Urgent Field Safety Notice
3mensio Workstation (Vascular – Fenestrated)
Version (10.6, 10.6 SP1, 10.6 SP2, 10.6 SP3, 10.6 SP4, 10.7, 10.7 SP1)

The purpose of this letter is to advise you that Pie Medical Imaging is issuing an urgent Field Safety Notice regarding the clock position visualization in the fenestration diagram in 3mensio Workstation 10.6 (Vascular – Fenestrated layout) or 3mensio Workstation 10.7 (Vascular – Fenestrated layout).

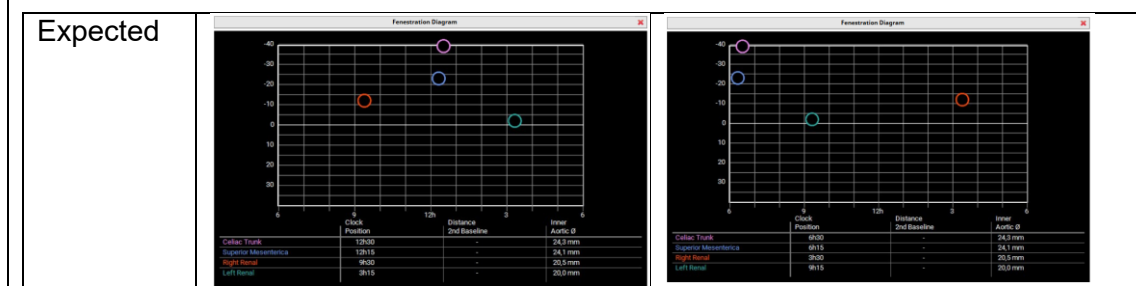
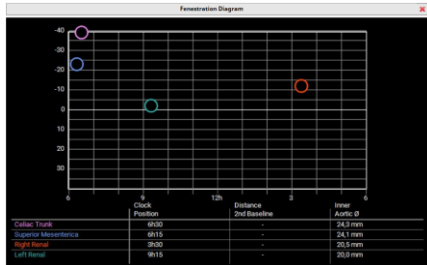
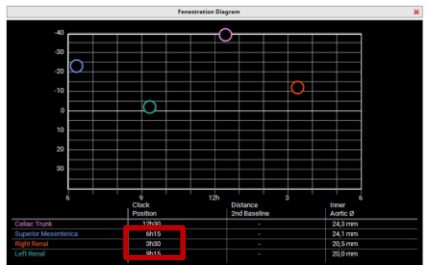
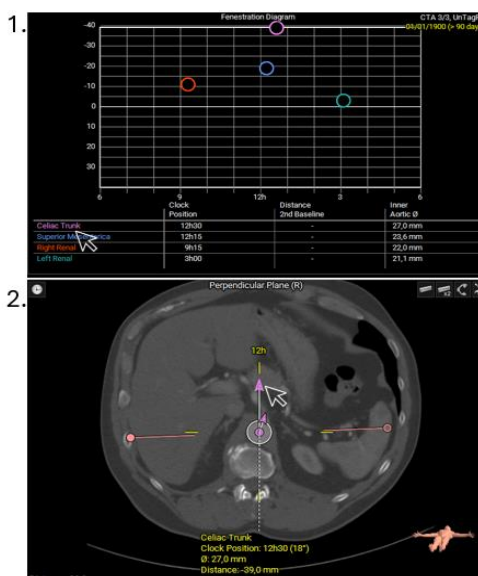
Observed behaviour: In the fenestration diagram only the adjusted clock measurement is updated to the new 12h position. The other clock measurements are not updated relative to the new 12h position

Impact: The hazard exists that the clock positions are not correct in the report causing fenestrations on a stent graft at an incorrect position. This could potentially be harmful for the patient since this could potentially lead to permanent tissue damage. If FSN advice is followed there is no residual risk.

In case you open a session state with saved clock measurements created in **3mensio Workstation 10.6** and there is a need to adjust the **12h position** for the clock positions, make sure to update **all** individual clock measurements in the perpendicular plane by the following steps:

1. Click on the clock position.
2. Update the 12h pointer of the clock in the perpendicular viewport.
3. Perform step 1 & 2 for all clock measurements in the analysis.

After updating all 12h pointers, the information shown in the fenestration diagram is correct and functionality is restored.
